David Wilson Homes

Response to WBC Highways

SLR Project No.: 184395

24 November 2025

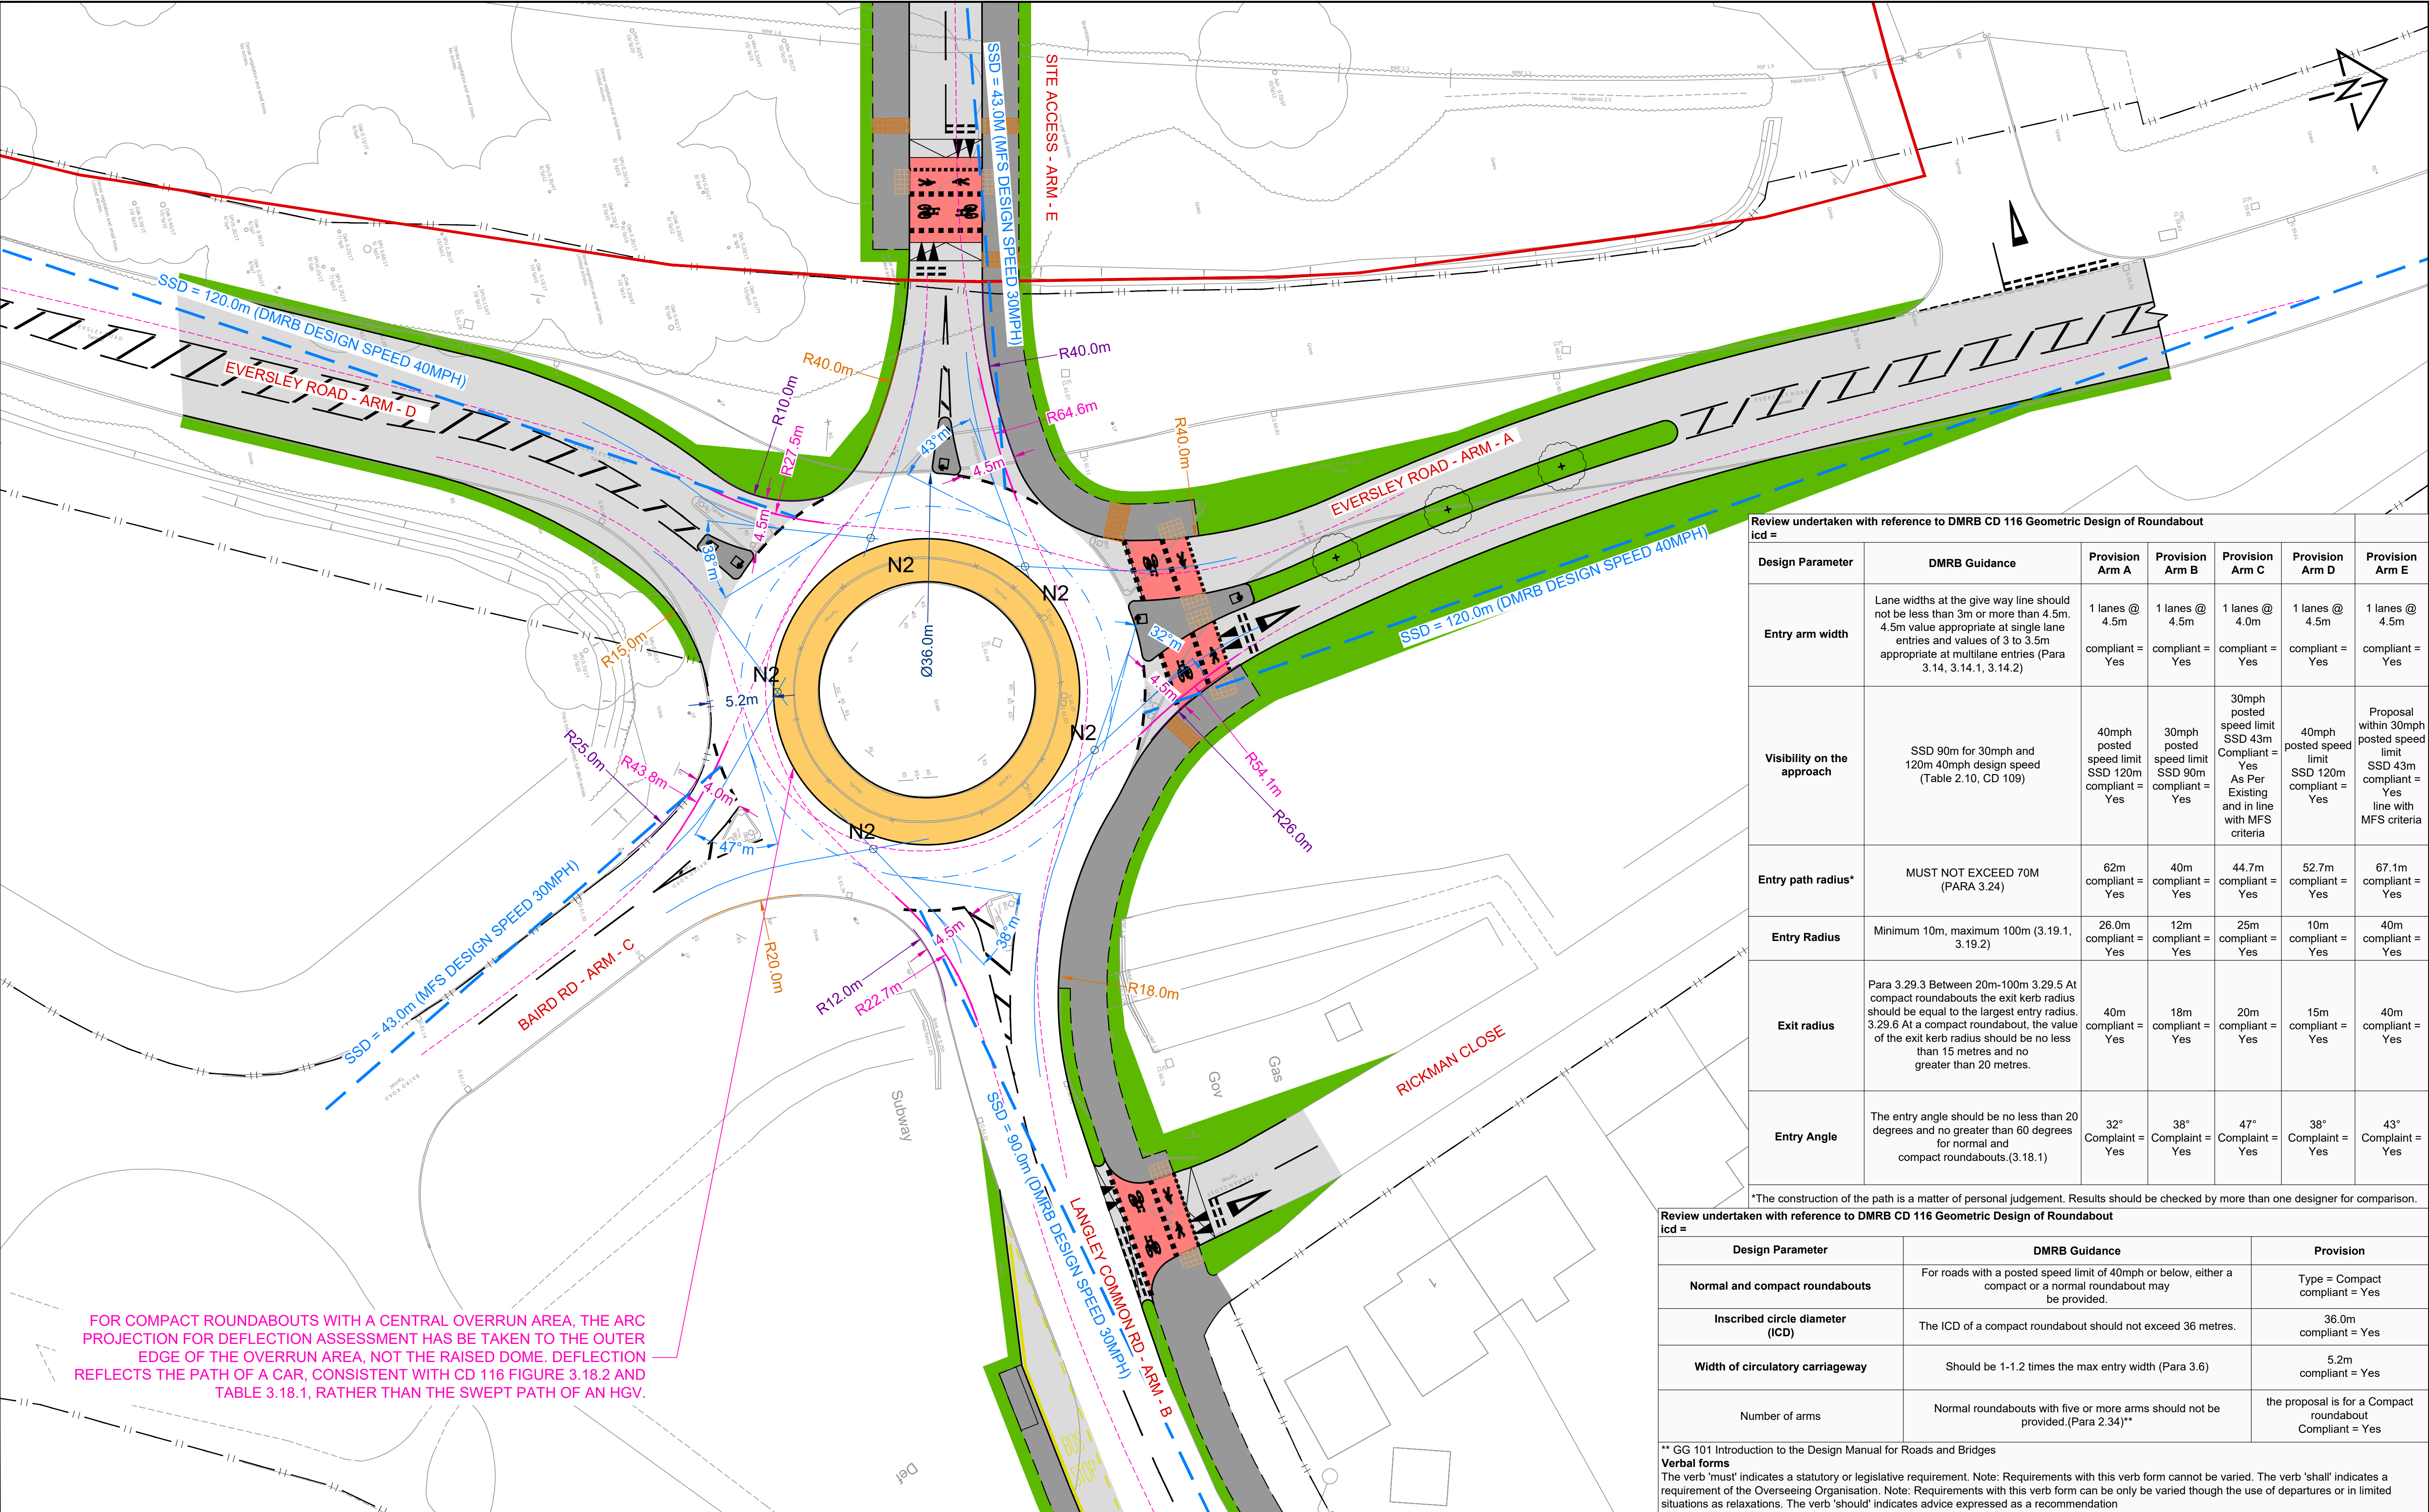
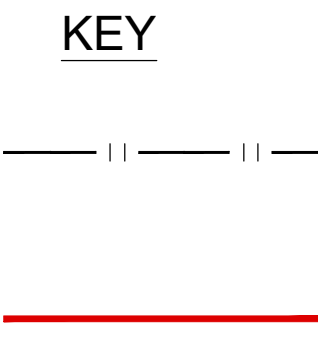
46. Paragraphs 46 and 47 outline the design requirements of CD116. Particular reference is made by WBC to paragraph 2.3.2, albeit this considers where speed limits are 50mph or higher. Given the 40mph speed limit, paragraph 2.3.3 which suggests compact roundabouts or a normal roundabout could be provided is more appropriate. With this in mind, given that CD116 states that normal roundabouts with 5 or more arms are not appropriate (2.3.4), it is clear that the compact arrangement is suitable to serve the site. A review of the design with consideration for CD116 has been undertaken and is included at **Appendix B**.

Review undertaken with reference to DMRB CD 116 Geometric Design of Roundabout						
icd =						
Design Parameter	DMRB Guidance	Provision Arm A	Provision Arm B	Provision Arm C	Provision Arm D	Provision Arm E
Entry arm width	Lane widths at the give way line should not be less than 3m or more than 4.5m. 4.5m value appropriate at single lane entries and values of 3 to 3.5m appropriate at multilane entries (Para 3.14, 3.14.1, 3.14.2)	1 lanes @ 4.5m compliant = Yes	1 lanes @ 4.5m compliant = Yes	1 lanes @ 4.0m compliant = Yes	1 lanes @ 4.5m compliant = Yes	1 lanes @ 4.5m compliant = Yes
Visibility on the approach	SSD 90m for 30mph and 120m 40mph design speed (Table 2.10, CD 109)	40mph posted speed limit SSD 120m compliant = Yes	30mph posted speed limit SSD 90m compliant = Yes	30mph posted speed limit SSD 43m Compliant = Yes As Per Existing and in line with MFS criteria	40mph posted speed limit SSD 120m compliant = Yes	Proposal within 30mph posted speed limit SSD 43m compliant = Yes line with MFS criteria

Entry path radius*	MUST NOT EXCEED 70M (PARA 3.24)	62m compliant = Yes	40m compliant = Yes	44.7m compliant = Yes	52.7m compliant = Yes	67.1m compliant = Yes
Entry Radius	Minimum 10m, maximum 100m (3.19.1, 3.19.2)	26.0m compliant = Yes	12m compliant = Yes	25m compliant = Yes	10m compliant = Yes	40m compliant = Yes
Exit radius	Para 3.29.3 Between 20m-100m 3.29.5 At compact roundabouts the exit kerb radius should be equal to the largest entry radius. 3.29.6 At a compact roundabout, the value of the exit kerb radius should be no less than 15 metres and no greater than 20 metres.	40m compliant = Yes	18m compliant = Yes	20m compliant = Yes	15m compliant = Yes	40m compliant = Yes
Entry Angle	The entry angle should be no less than 20 degrees and no greater than 60 degrees for normal and compact roundabouts.(3.18.1)	32° Complaint = Yes	38° Complaint = Yes	47° Complaint = Yes	38° Complaint = Yes	43° Complaint = Yes

PROPOSED PEDESTRIAN ACCESS TO THE SANG – HARTS CLOSE

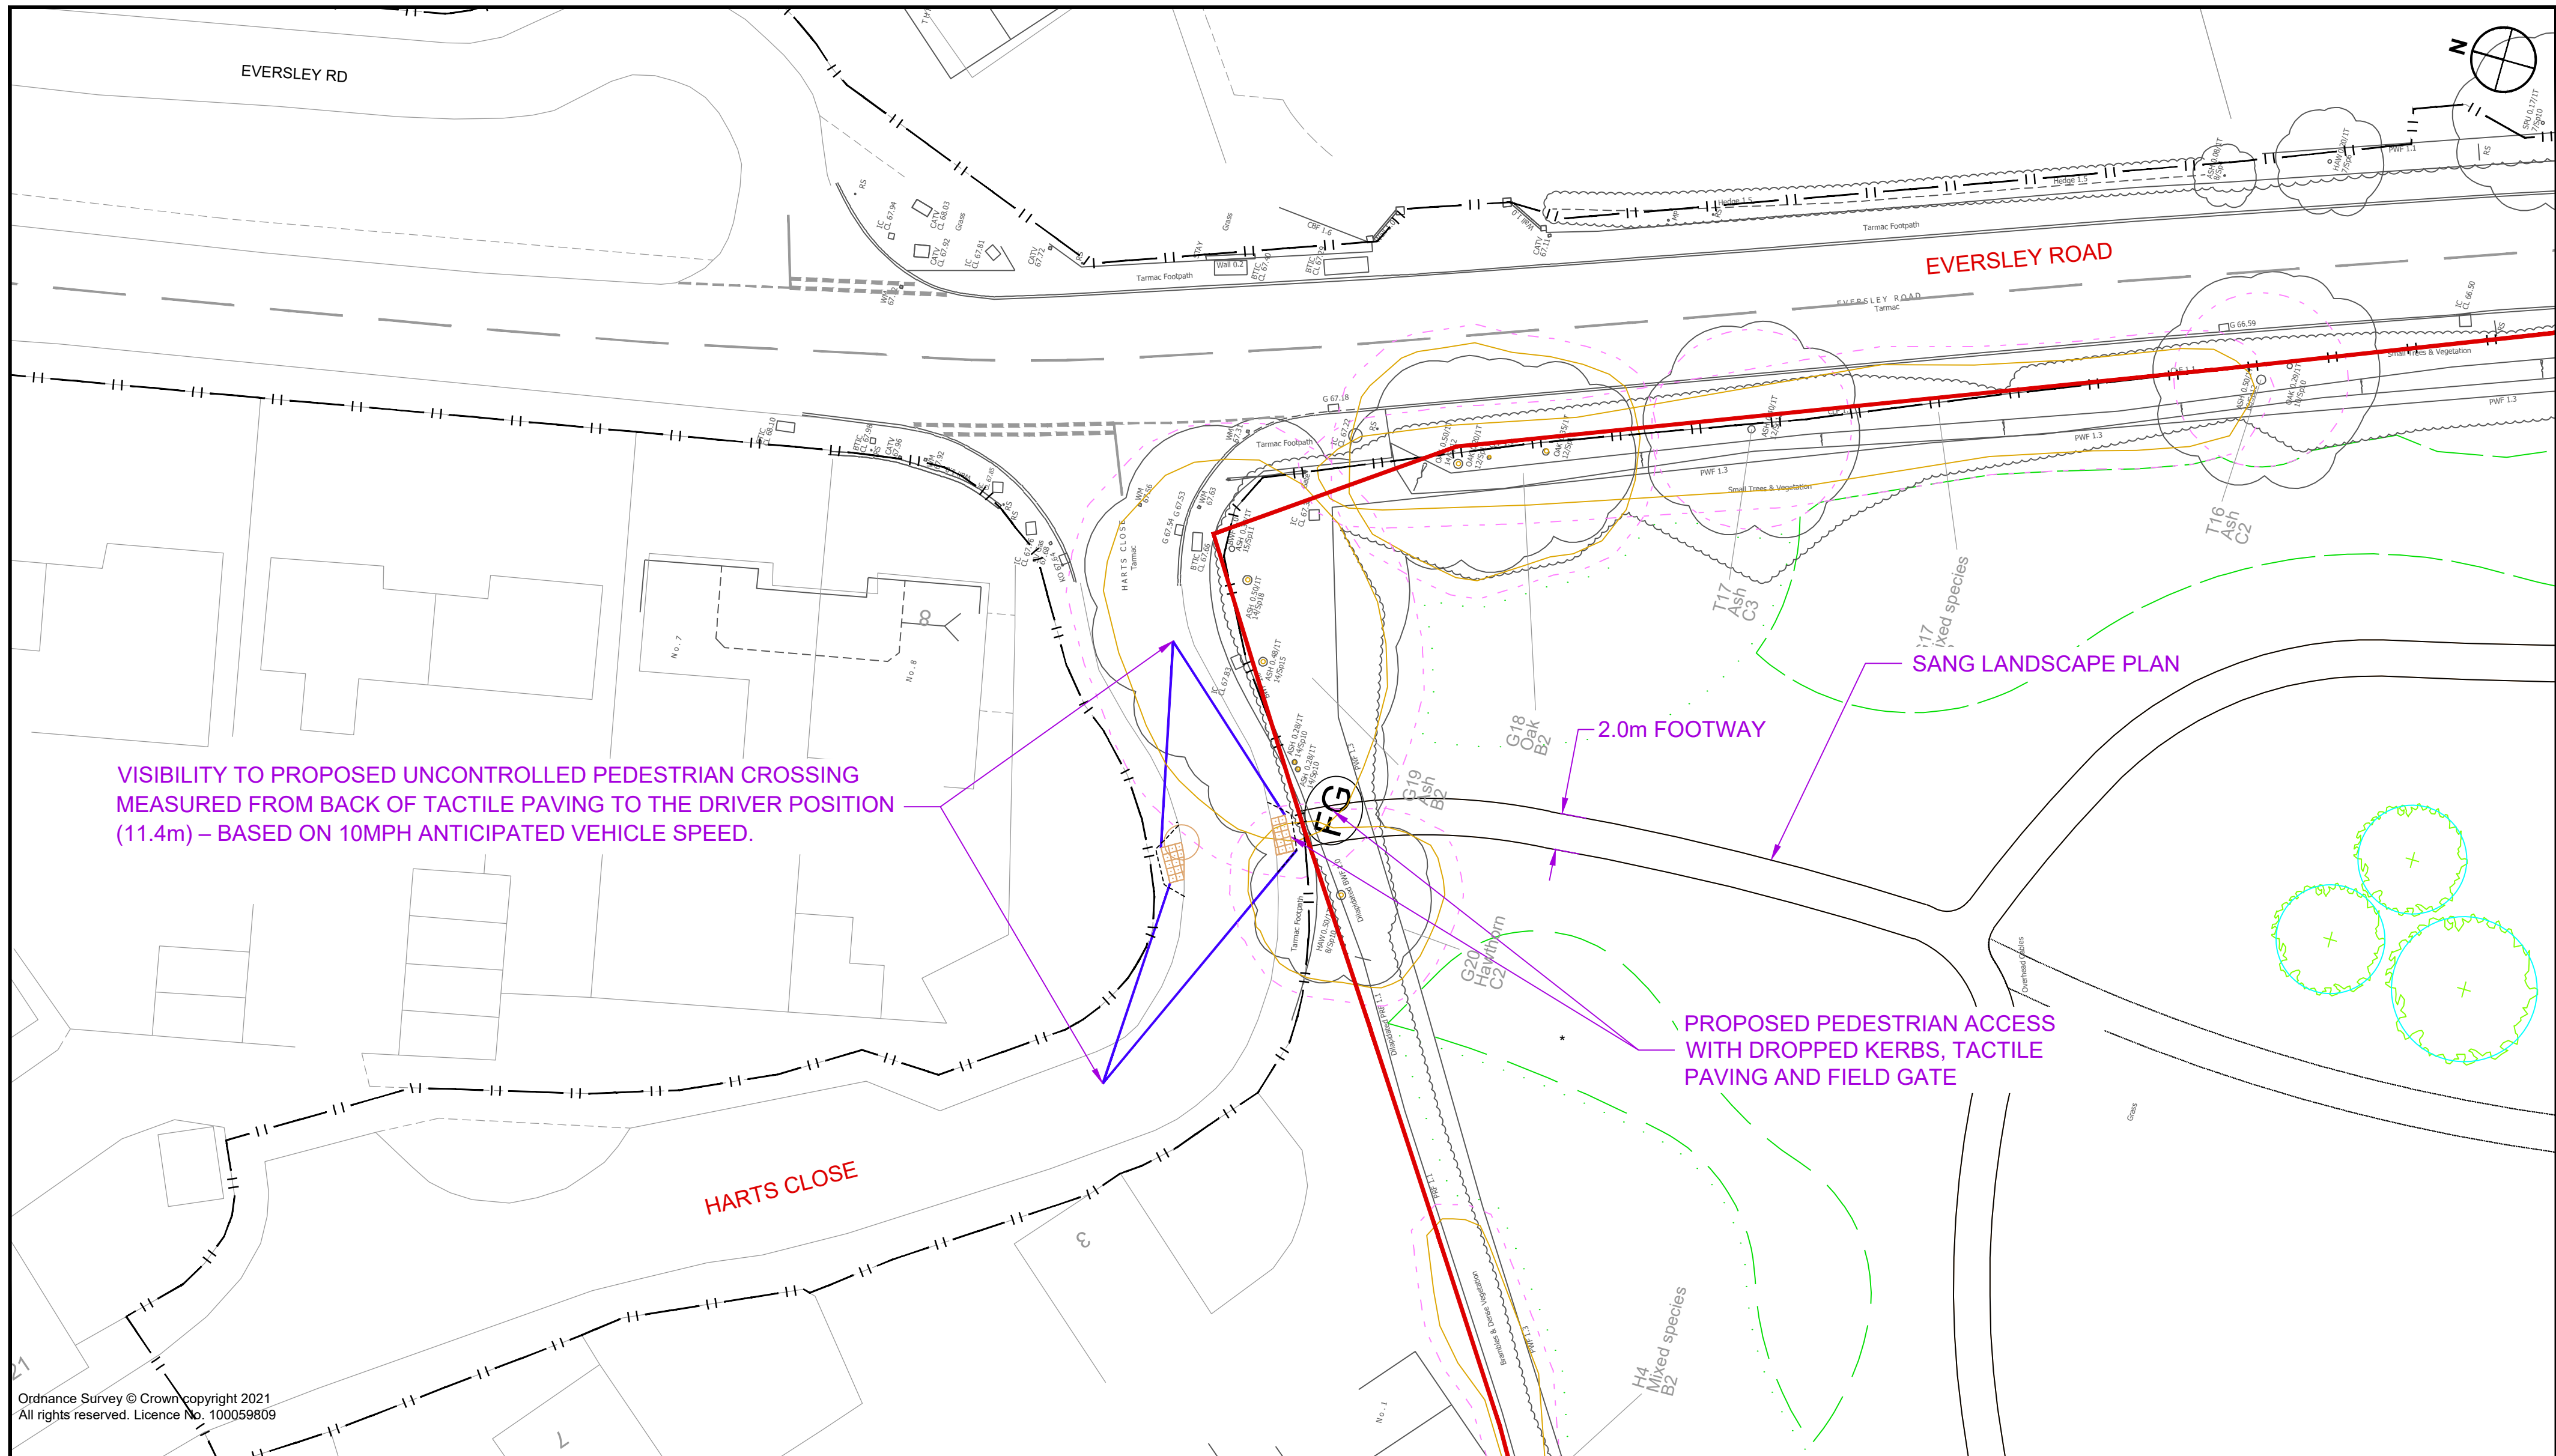
22. Paragraph 22 notes the proposed pedestrian access from Harts Close and suggests that a detailed drawing should be provided of the arrangement. This was included as Appendix E of the Transport Assessment, albeit has since been updated and is included at **Appendix B**.

39. Paragraphs 39 and 40 identify the submitted drawings. Notably, a revised drawing (184395_PD06 Rev D) has been prepared of the proposed pedestrian/cycle access which is included at **Appendix B**. This is no longer proposed to provide emergency access given the changes in where built form is proposed when compared to the previously withdrawn application.
